Rebuttal Report to Myers (2017)

PRESENTATION TO THE OFFICE OF THE NEVADA STATE ENGINEER

Submitted to:
Jason King, P.E., State Engineer
State of Nevada
Department of Conservation & Natural Resources
Division of Water Resources
901 S. Stewart Street, Suite 2002
Carson City, Nevada 89701

Pertaining to:
Groundwater Applications 54003 through 54021 inclusive
and
53987 through 53992 inclusive

Figure 1
CCRP Model Simulated Versus Observed Flows at Muddy River Gages

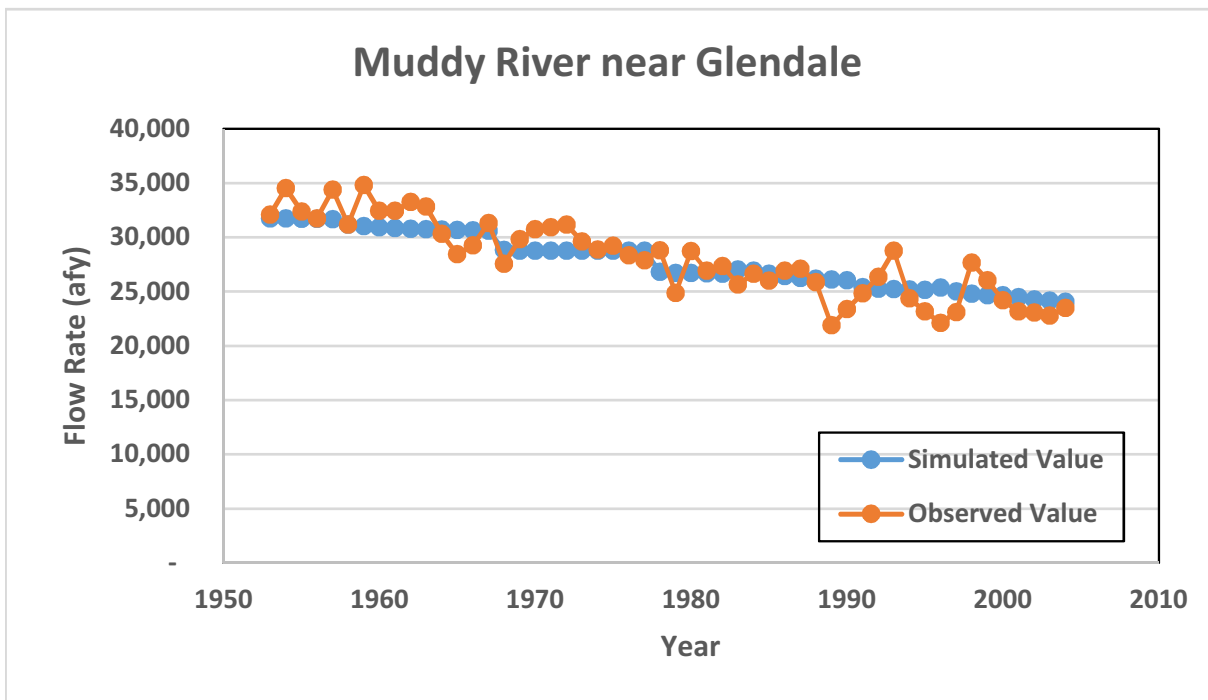
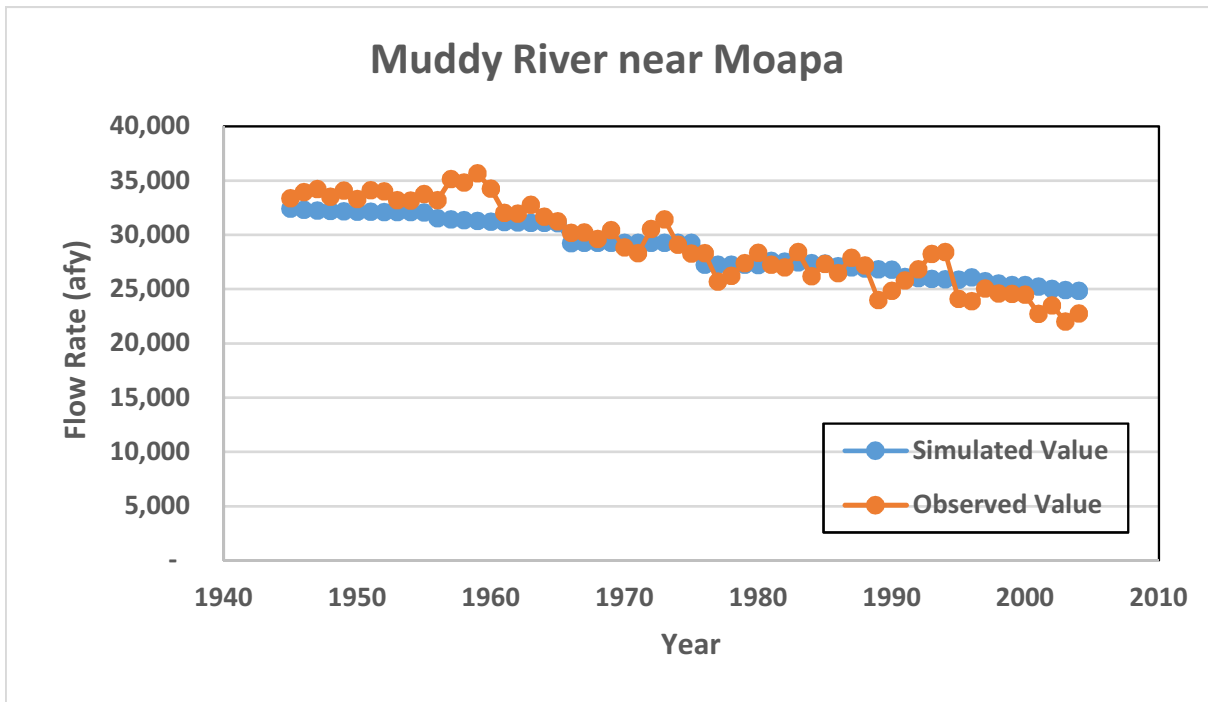
12. Myers reviews and criticizes how flow across the Pahranaagat Shear Zone is simulated in the CCRP model and the simulated spring flows in the Muddy River springs under Alternatives E and F on pages 58 through 65.

This is not relevant to the four remand issues. The CCRP model is the best model available to date and was selected by both the NSE and the BLM to perform broad regional analyses. This model represents flow across the Pahranaagat Shear Zone as accurately as possible based on the available information. The width of the faults follows the grid resolution, and the aquifer properties represent averages across the cells and were adjusted during calibration to match spring flows and water levels. The fact that the flows simulated in the Muddy River near Moapa and near Glendale reasonably match the observed flows at these locations (Figure 1) prove that Myers' assertions are unfounded. Contrary to Myers' insinuation that SNWA represented the faults to minimize effects of pumping, Figure 1 shows that SNWA's fault representation is adequate at the regional scale because it allows the model to simulate the historical flows in the Muddy River relatively well.
